Dublin Commuter Coalition
5 Abbeyfield
Killester
Dublin 5

ABP case ref: 313892

BUSCONNECTS BLANCHARDSTOWN CORE BUS CORRIDOR SCHEME

Figure 15: Auburn Ave junction

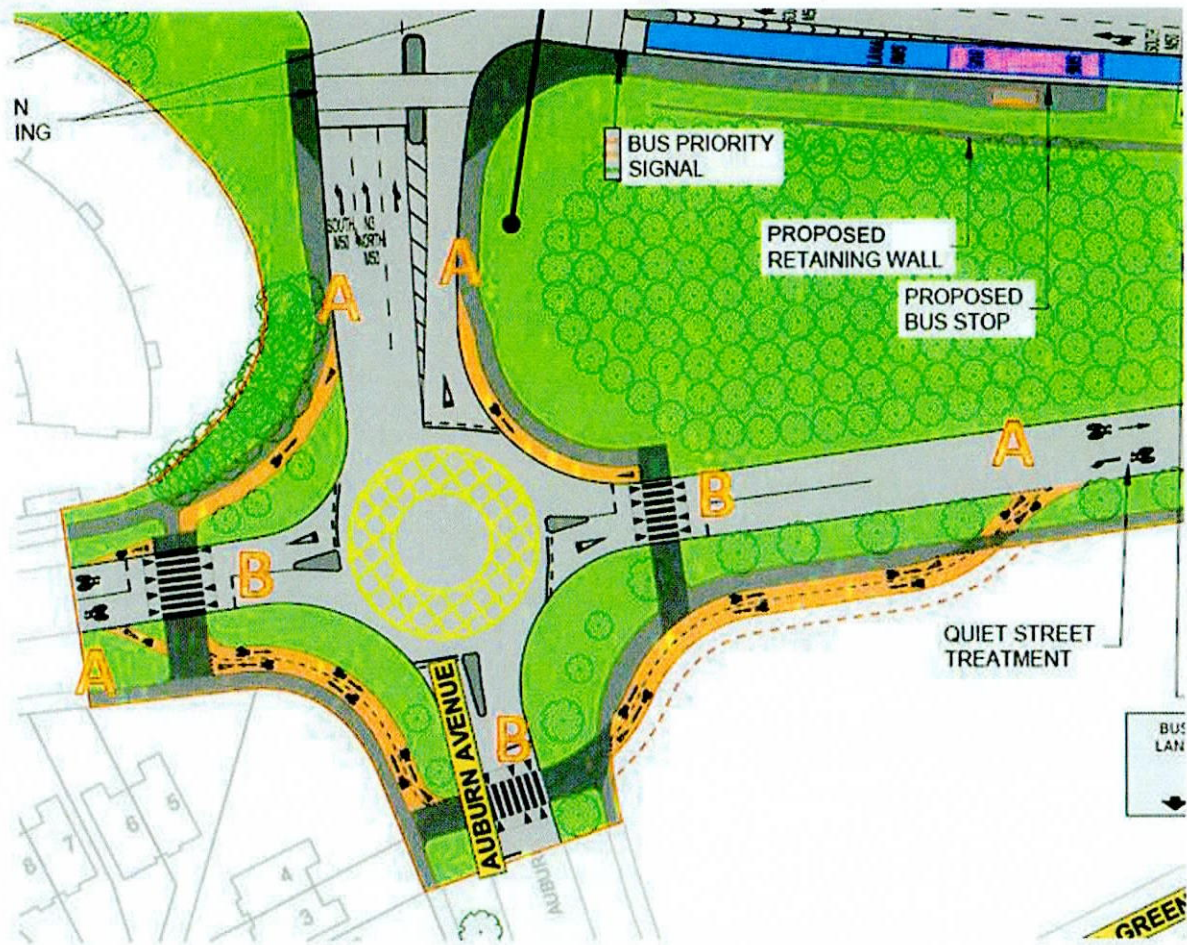
In Figure 15 below, at points A the way the cycleway merges with the main carriageway is unnatural and seems likely to generate conflicts between motorists and cyclists potentially leading to dangerous collisions. At points B, the use of "shared space" is both unnecessary and dangerous. There is ample space for segregated cycle and pedestrian crossings at these zebra crossings. It is unwise and unnecessary to merge cycle lanes and footpaths here in this manner. Doing so is likely to generate conflicts between pedestrians and cyclists potentially leading to dangerous collisions.

What is involved in the "Quiet Street Treatment" is unclear on the right of Sheet 7, and visible below at the most rightward A. It is not clear what will be used to reduce conflict between pedestrians and motorists here and what "treatment" will ensure that it is a quiet street.

Figure 16: Navan Road Parkway Station

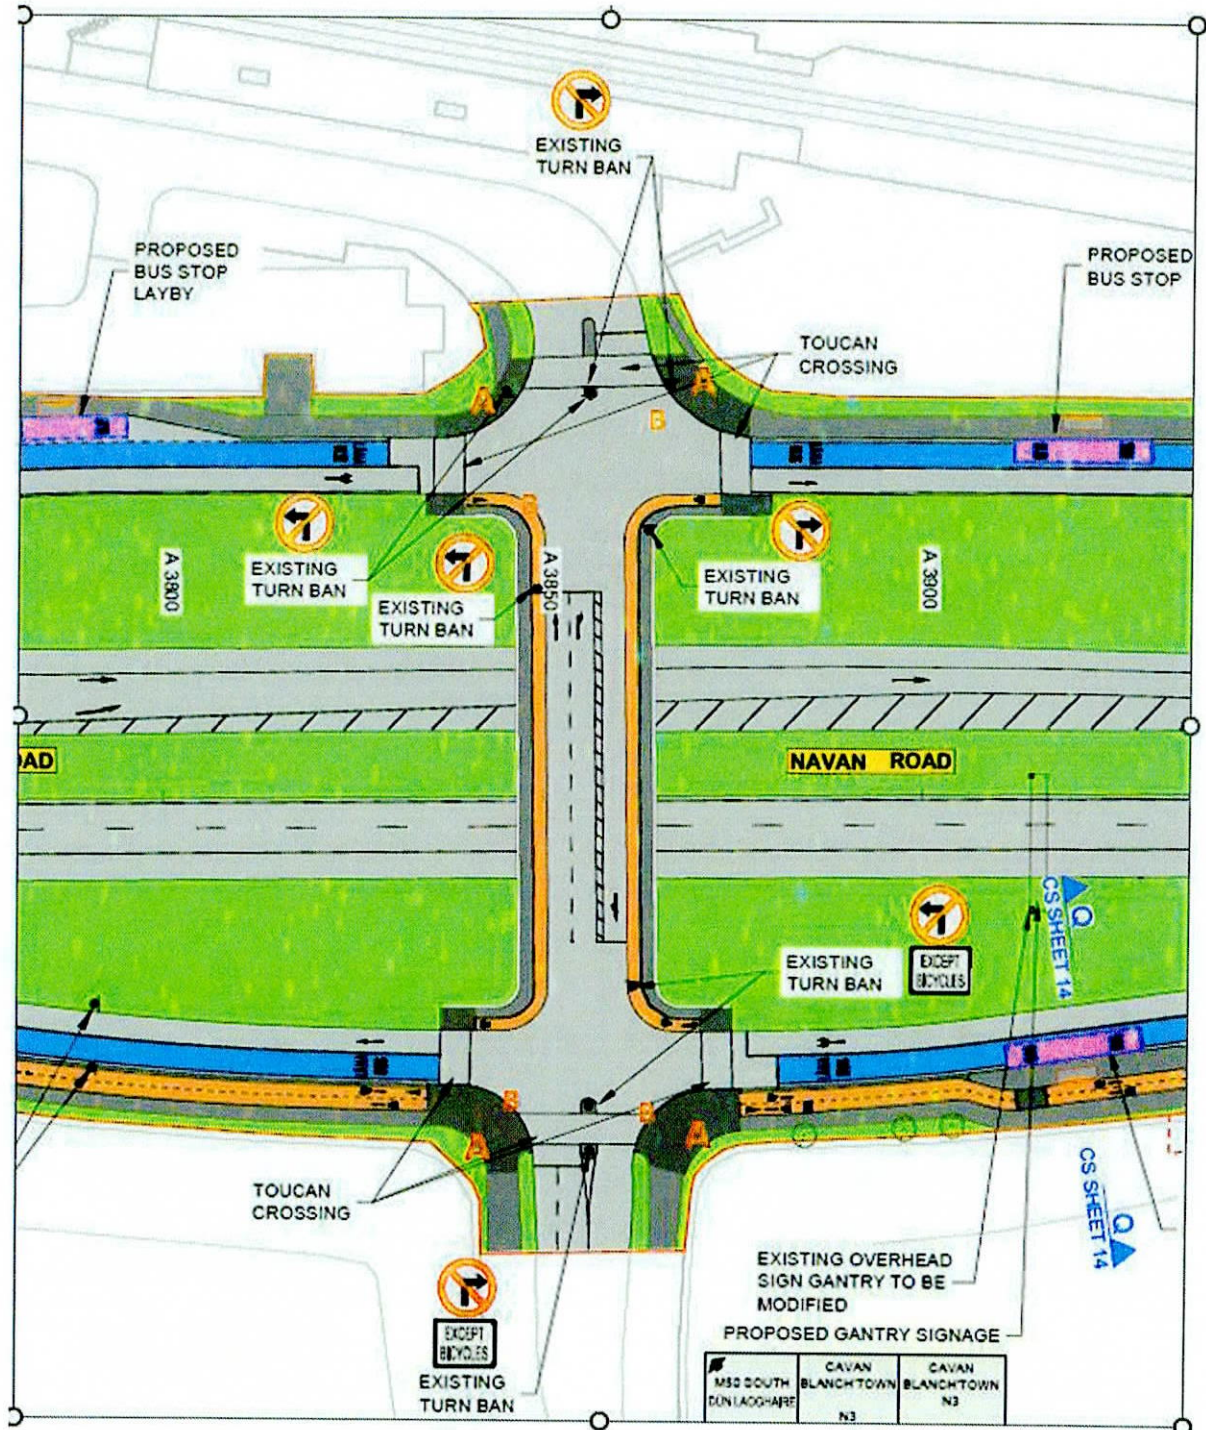
With the development of DART+, the Navan Road Parkway Station will become an important DART station. Therefore, ensuring safe access to it is important. However, the current design of the pedestrian and cyclist infrastructure at the bridge over the Navan Road and into the station is very poor and likely to generate conflicts both between motorists and cyclists and between pedestrians and cyclists potentially leading to dangerous collisions.

The pedestrian and cyclist "shared space" at points A on Figure 16 are unsafe and should be removed. The sharp curves in the cycle lanes at either side of the bridge are unlikely to be observed and are unsafe.

These junctions should be changed to bring the junction in line with best practice. (See comments regarding "Dutch-style" junctions above.) This might involve ensuring that (a) the merging of pedestrian and cyclist space is removed or reduced to a minimum, (b) cycle lanes allow for cyclists to move across the junction in a

natural manner without large unnatural bends, or without needing to dismount or merge with pedestrian space, (c) cyclists waiting points at junctions are moved out and ahead of motorist waiting points. For the last point we suggest moving cyclist starting points to points B on figure 16 below.

Figure 17: Junction at Phoenix Park Ave

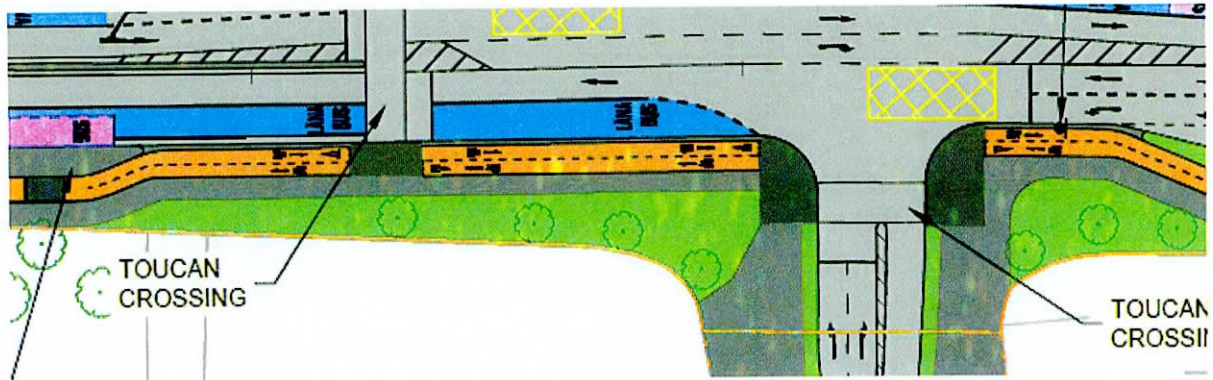
Relatively simple repositioning of the cycle lane, footpath and pedestrian crossing at junction of Phoenix Park Ave and the Navan Road (Sheet 20) would remove pedestrian/cyclist conflicts here. (See figure 17 below.)

The shared pedestrian/cyclist space at the junction should be removed, so that pedestrian and cyclist space is segregated at this junction.

Also, to the left of the junction in Figure 17, a pedestrian waiting point between the cycle lane and the main carriageway could be created by repositioning cycle lane. Currently, the design would appear to encourage pedestrians to wait for the traffic lights to change by standing in a cycle lane.

Figure 18: Junction at Phoenix Park Ave

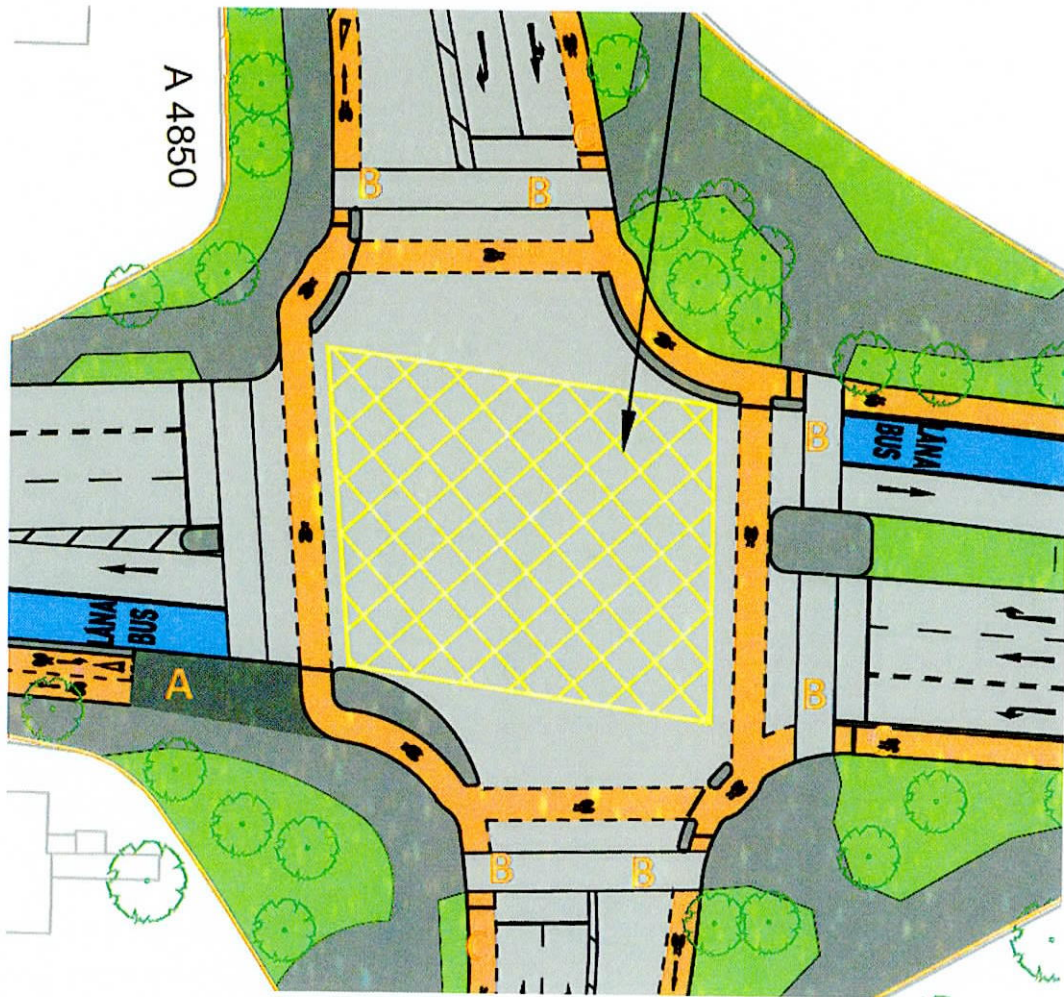
As with many of the junctions in the first part of this submission, this is an example of a "Dublin style" junction. It should be replaced with a "Dutch-style" junction. This would involve removing the shared cyclist/pedestrian space at A on Figure 18 and replacing it with a segregated cycle lane and a pedestrian waiting point between the cycle lane and the main carriageway. Similar pedestrian waiting points should be created at the six point Bs. And the cyclist waiting points should be moved from points C so the waiting point for cyclists going straight is substantially ahead of the waiting point of motorists who may be turning left, with appropriate changes made to traffic light signalling for both cars and cyclists.

Figure 19: Junction at Kempton Ave

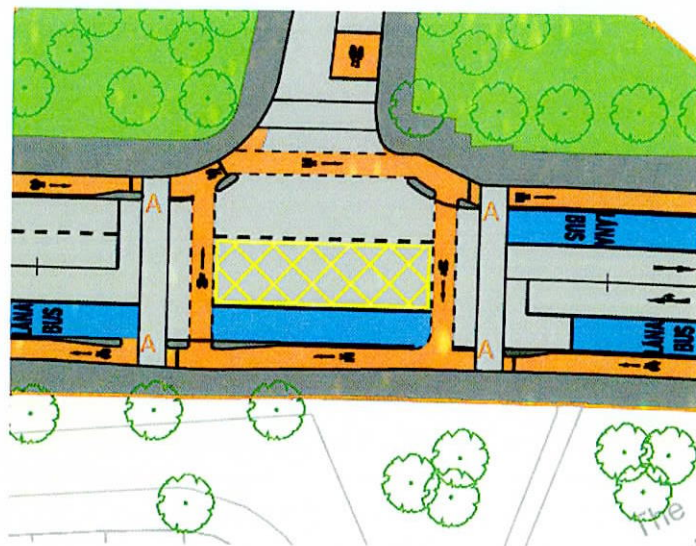
To minimum pedestrian/cyclist conflict at the junction of the Navan Road and Kempton Ave (Sheet 22), pedestrian waiting points should be created at points A in Figure 19 below.

Figure 20: Junction at Ashtown Grove

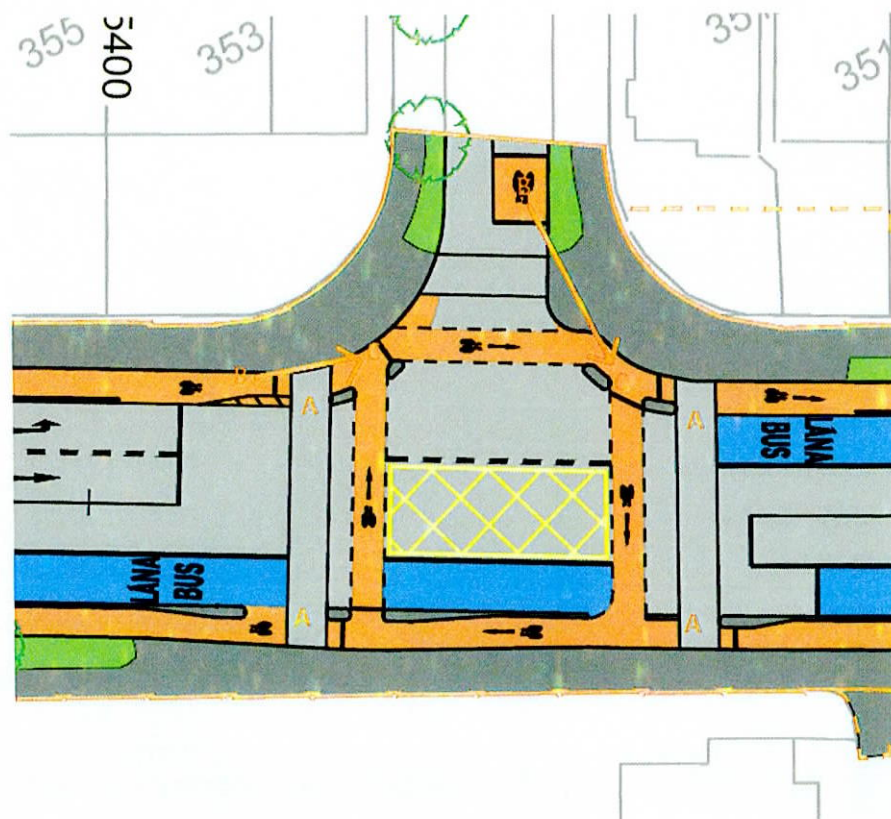
Likewise, to minimum pedestrian/cyclist conflict at the junction of the Navan Road and Ashtown Grove (Sheet 23), pedestrian waiting points should be created at points A in Figure 20 below. And cyclist waiting points should be moved from points B to points C with appropriate changes made to traffic light signalling for both cars and cyclists.

Figure 22: Junction of Navan Road and Old Cabra Road

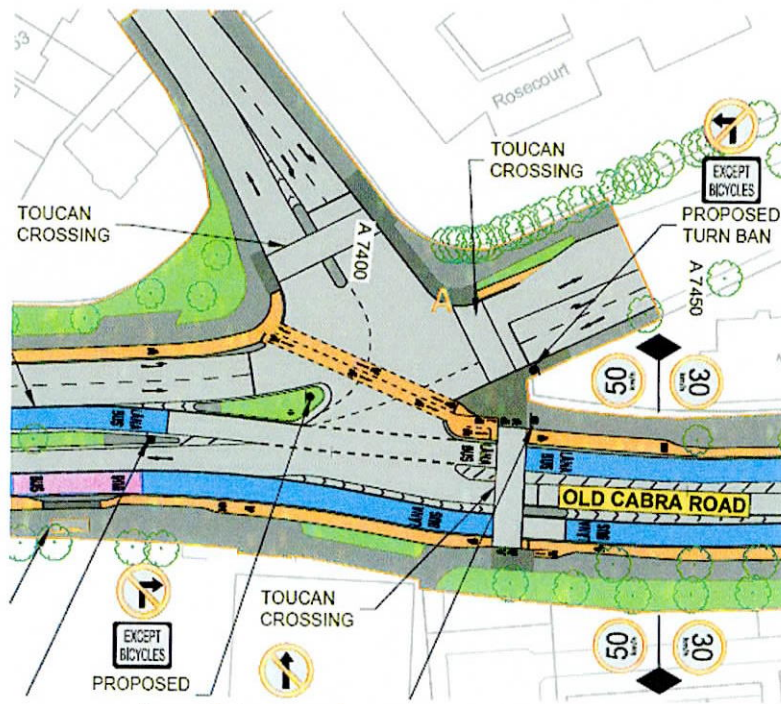
There is an excessive use of shared space between cyclists and pedestrians at the junction of Navan Road and Old Cabra Road (Sheet 28). This is most problematic at point A in Figure 22 below where does not appear to be any proper allowance for cyclists going straight from the Navan Road to the New Cabra Road.

Figure 23: The Junction of Brunswick St North and Stoneybatter

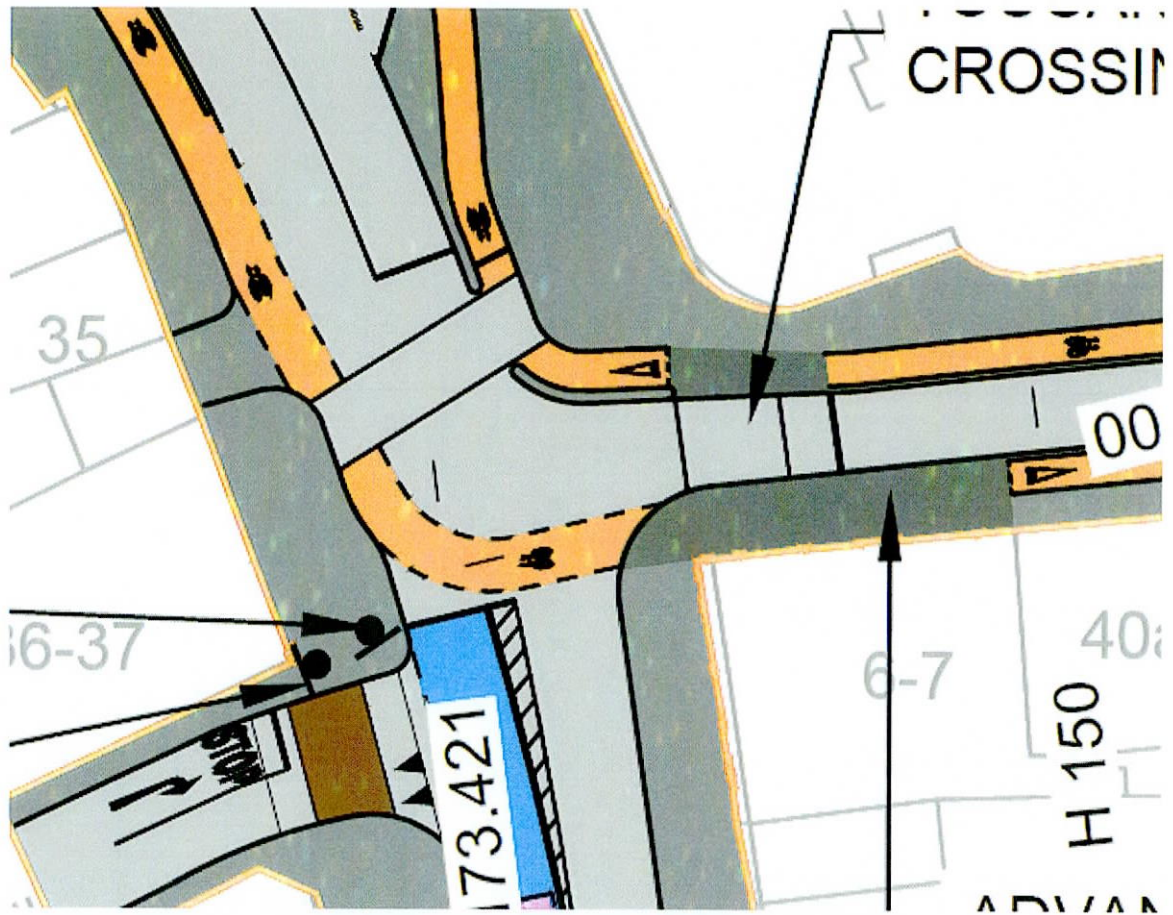
We recommend against the creation of a shared space at the junction of Brunswick Street North and Stoneybatter (Sheet 34). (See Figure 23 below.) This is a bad idea in at least three ways.

Firstly, the use of "shared space" by cyclists and pedestrians is always a bad idea and should be avoided.

Secondly, this results in the waiting point for cyclists at this junction being behind the waiting point for motorists and well back from the actual junction. This is already a very difficult and dangerous junction to navigate for cyclists when their starting is well ahead of this point, it would be almost impossible with a waiting point this far back from the junction.

Thirdly this shared space is outside a popular pub "Walsh's". The pub does not have a smoking area, so this is when this pub is open, there are nearly always people drinking and smoking cigarettes in this exact area. To direct a major arterial cycle lane into a "shared space" that is effectively the smoking area of a popular pub, frankly, is completely daft.
